Specification / Drawing Change Notice

SANYO DENKI Ref. No.: A0050472B

Product Affected: San Ace 200 9GV type
9GV2048P0G201, 9GV2048P0G203, 9GV2048P0G204,

Model No.: 9GV2048P0G205, 9GV2048P0G206, 9GV2048P0G207

Outline drawing before change (Reference)

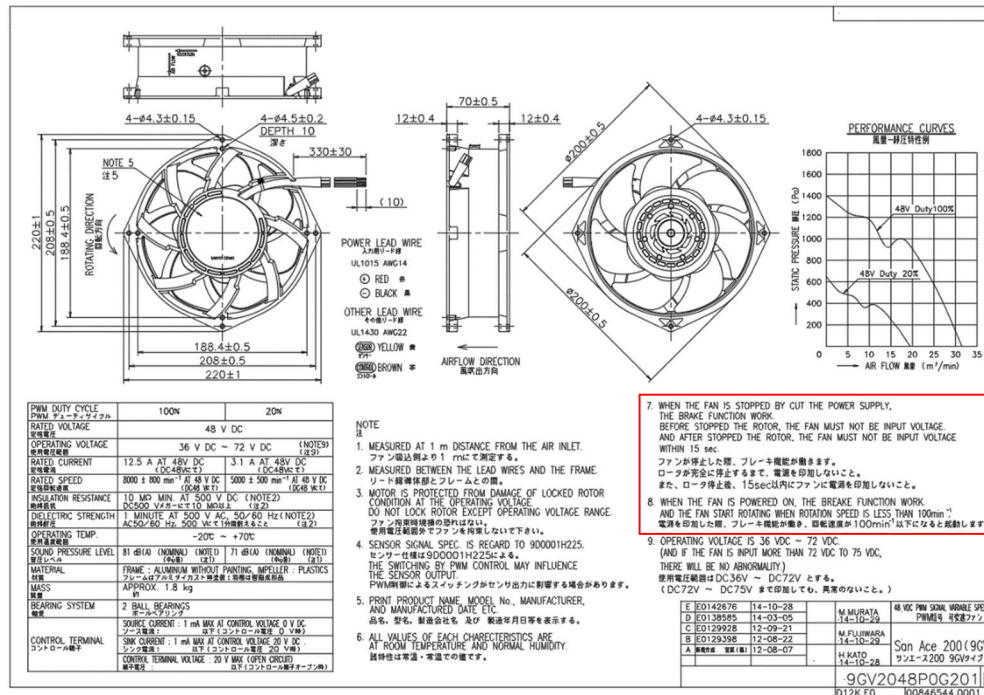
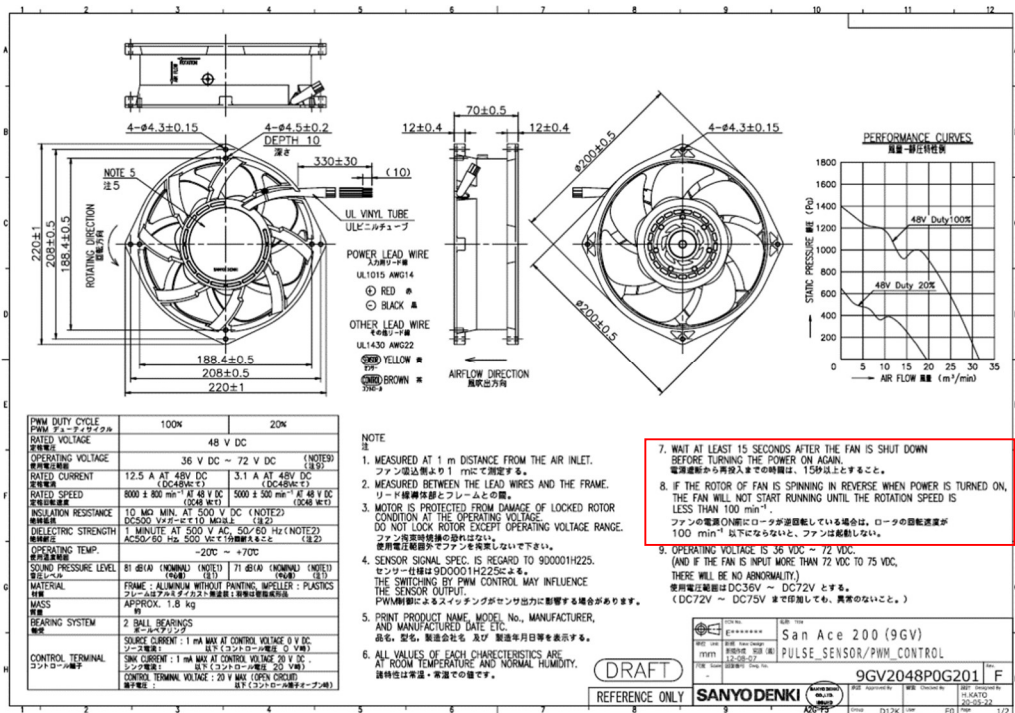
Item 3	Outline Change of the control when power is turned off
	Before Change The brake work temporarily when power is turned off.
	After Change The brake does not work when power is turned off.
	Reason for Change The control when power is turned off will be changed to match the specifications of the changed IC [PIC16F1828]. And it will be changed relevant notes of outline drawing.

Item 4	Outline Change of the control when power is turned on
	Before Change If the rotor of fan is spinning when power is turned on, the fan does not start running until the rotation speed is less than 100 min ⁻¹ .
	After Change If the rotor of fan is spinning <u>in reverse</u> when power is turned on, the fan does not start running until the rotation speed is less than 100 min ⁻¹ .
	Reason for Change The control when power is turned on will be changed to match the specifications of the changed IC [PIC16F1828]. And it will be changed relevant notes of outline drawing.

Outline drawing after change (Reference)
